EPYLLION STYLE LTD. (EXTENSION 2)

7 May 2026

Structural Inspection Report

Observation-01: Punching shear stress in foundation exceeds normal design limit (Building 1).

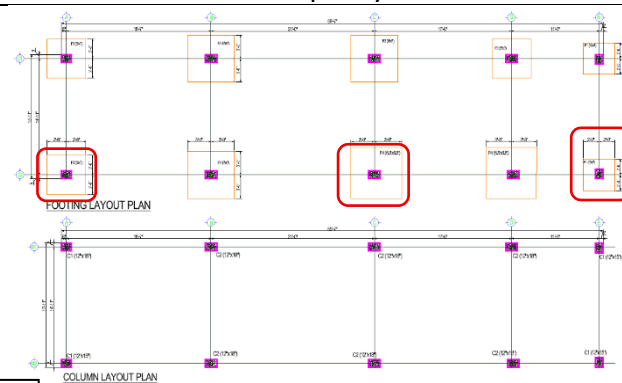
Description: cursory calculations indicate that some of the footings are experiencing punching shear stresses marginally exceeding the normal design limit, considering the prepared live load plan and the design concrete strength. The building engineer is required to review the design loads and foundation stresses in accordance with BNBC 2020 and submit the revised design documents to RSC for review.

Observation-02: Discrepancy in foundation size of mezzanine floor (Building 1)

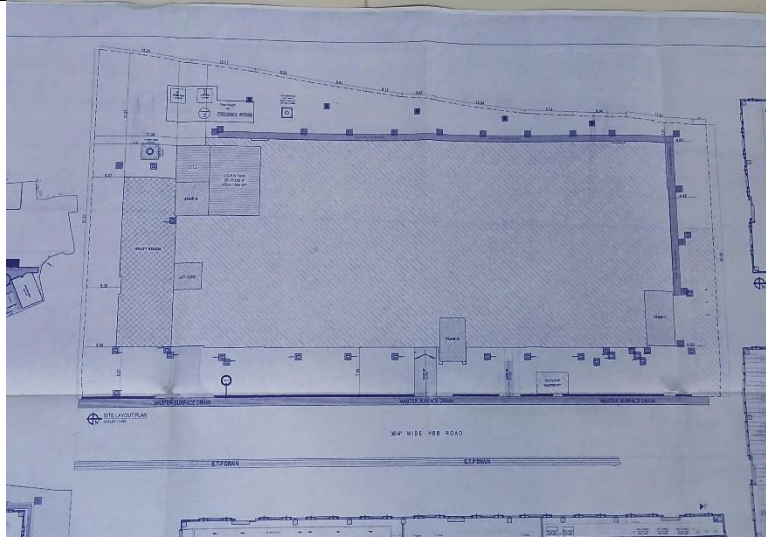
Description: During inspection, the foundation of self-supported mezzanine floor was overlapped with the main building foundation as per provided drawing. The building engineer is required to survey the whole structure and update the as-built drawing and design documents as per on site condition and submit to RSC for review.
